1 MAY 1956

MODIFICATION OF HAMMARLUND COMMUNICATION RECEIVER
MODEL SP-600-JX-17 TO INCREASE OPERATIONAL EFFICIENCY

T.O. 31R2-4-18-502

Figure 1. Location of IF Gain Label and Card Holder

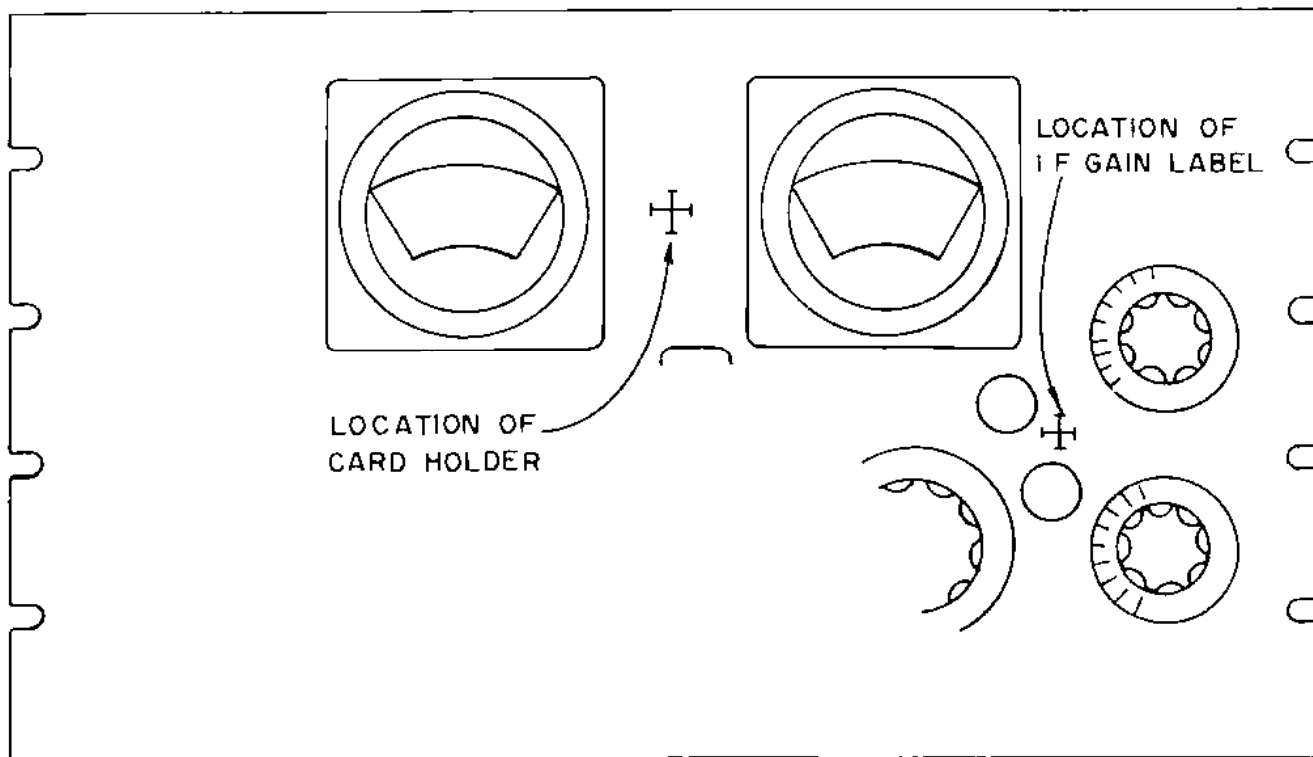
a. Addition of an "IF Gain" label and card holder to the front panel to provide operational and maintenance information.

b. Addition of IF Gain label and card-holder to the front panel (see Figure 1).

(1) Remove bottom plates from receiver and tuning unit.

(2) Remove dial lock knob and assembly, retaining the knob, nut and lockwasher for later use with new IF Gain control.

- (3) Place the receiver on its back with the front panel up, in horizontal position.
- (4) Clean the panel surfaces between dial escutcheons and around lettering of dial tuning lock, using an approved cleaning solvent such as trichlorethylene.
- (5) Apply a coating of toluol, supplied in capsule form in the kit, to rear surfaces of IF Gain label and card holder.
- (6) Wait about 30 seconds or until surfaces are tacky, then place the IF Gain label centered over the dial tuning lock lettering, and the card holder centered between the dial escutcheons. Apply even pressure to both labels and allow the adhesive material to harden.

Figure 2. Installation of IF Gain Control

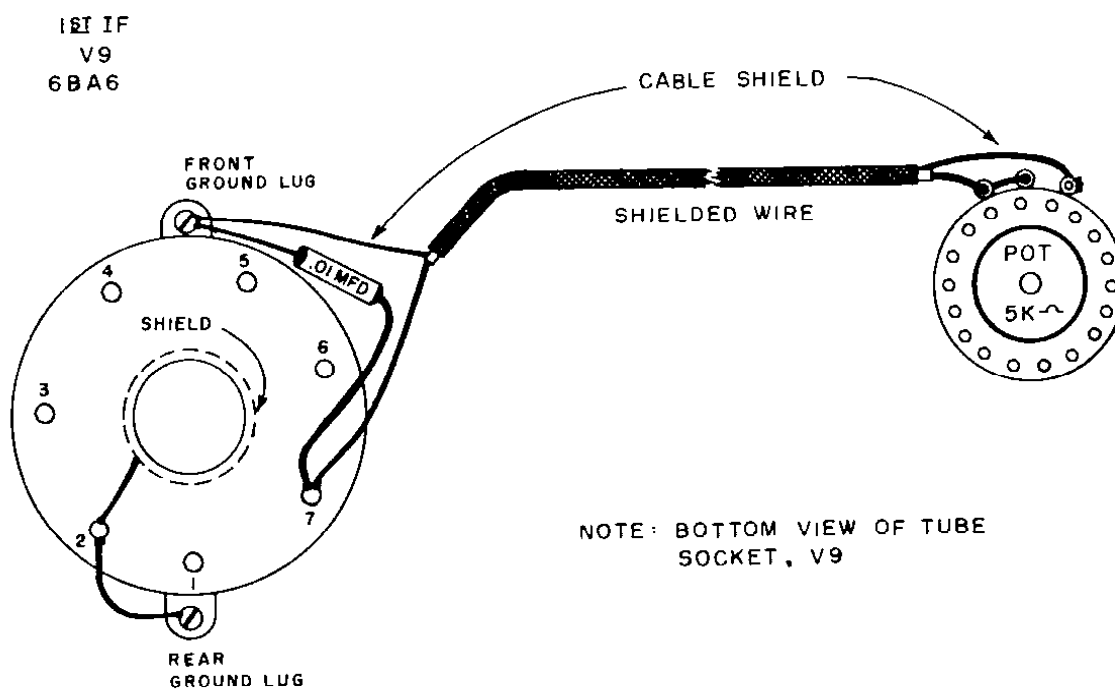
b. Addition of an IF Gain control for threshold adjustment of overall receiver gain to provide necessary balance in receiver gain for use in diversity service.

- (1) With receiver's bottom up; feed free end of the new IF Gain control cable through the grommet in front skirt of chassis and install the IF Gain control on the front panel, using the hole from which tuning lock was removed.

- (2) With the terminals of the new IF Gain control facing upward, toward bottom of receiver, secure the control using the lockwasher and nut previously removed from the tuning lock.

- (8) Replace tuning unit bottom cover.
- (9) Unsolder and remove wire connections between pin 7 and center-shield of socket for tube V9 and the chassis.

- (10) Connect pin 2 and center shield of socket for tube V9 to the rear ground lug of this socket (see Figure 2).
- (11) Connect the center conductor of new cable together with one lead of new 0.01 mfd capacitor to pin 7 of socket for tube V9 (see Figure 2).

- (12) Connect other lead of the new capacitor and cable shield to the front ground lug of the socket for tube V9 (see Figure 2).
